**Nebraska Public Power District**

NLS2008084  
November 6, 2008

**Subject:** Response to Nuclear Regulatory Commission Request for Additional Information  
Re: Reactor Equipment Cooling System (TAC No. MD8374)  
Cooper Nuclear Station, Docket No. 50-298, DPR-46

### Response to Nuclear Regulatory Commission Request for Additional Information Re: Reactor Equipment Cooling System (TAC No. MD8374)

FIGURE 1

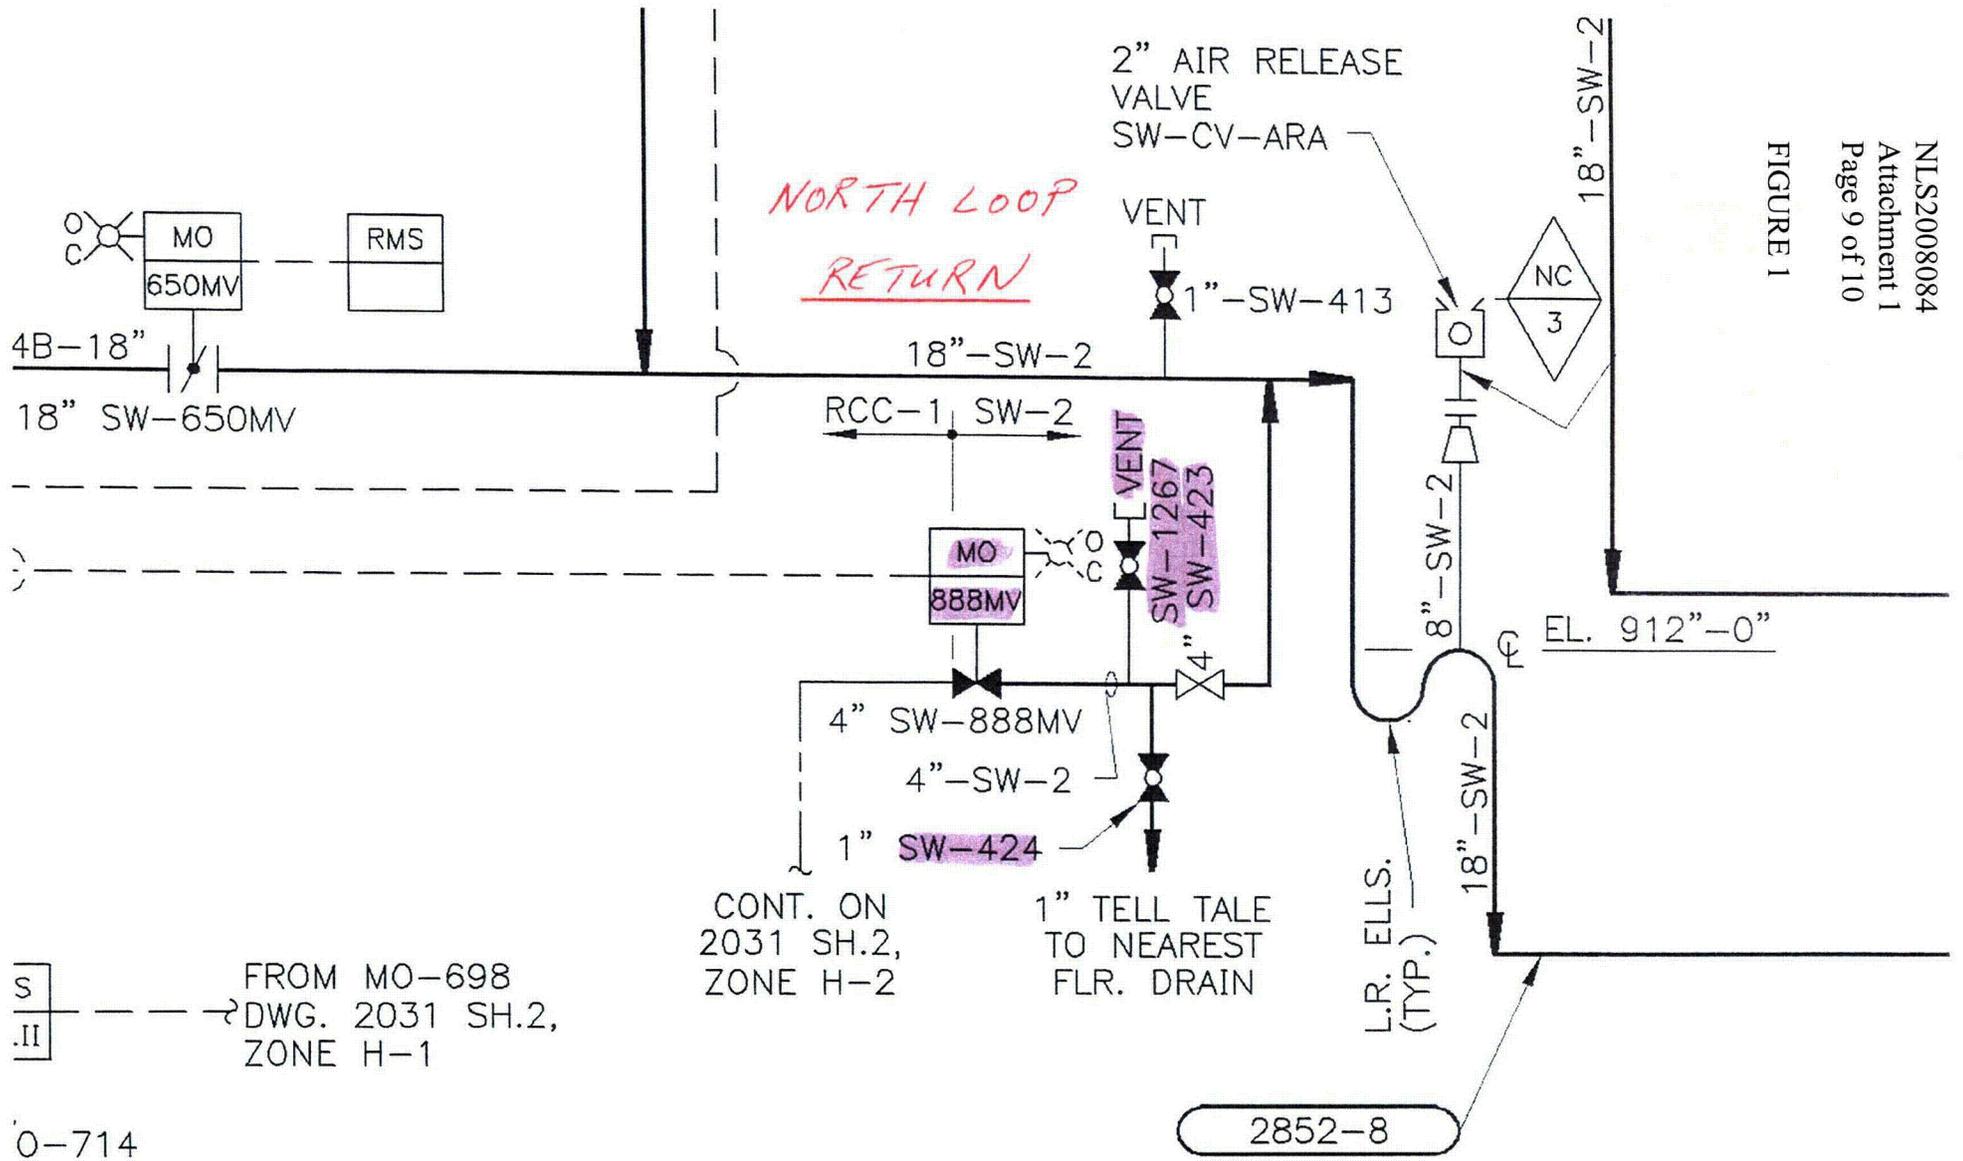
*On page 9 of Attachment 1 of the LAR, the licensee states its preference to use the REC System following a LOCA as opposed to the SW System, which contains silt from the Missouri River. However, the LAR proposes to utilize the SW System at any time to provide cooling water to the ECCS pump room coolers following a LOCA. [a] How does the licensee factor into its calculations the amount of silt being introduced to the ECCS pump room coolers, especially if the SW System can be used at any time after a LOCA? [b] When the SW System is in use, how will the licensee monitor the amount of silt going into the ECCS pump room coolers to ensure proper cooling will be provided throughout the mitigation period of 30 days after a LOCA?*

Figures 1 and 2, showing portions of the SW System at the crossties to the REC System, are provided as an aid in understanding the following discussion of the piping configuration.

[Refer to Figure 1.] With 4-inch motor operated valve (MOV) SW-888MV closed and 4-inch manual valve SW-423 open, the SW-to-REC crosstie is normally pressurized from the SW side. Surveillance of the SW Backup Cooling alignment first involves opening the 1-inch crosstie drain valve (SW-424) on the return side until a steady flow of SW water is observed. Valves SW-424 and SW-423 are then closed. The crosstie return piping is next vented and drained through valves SW-424 and SW-1267. These valves are then closed to isolate the crosstie.
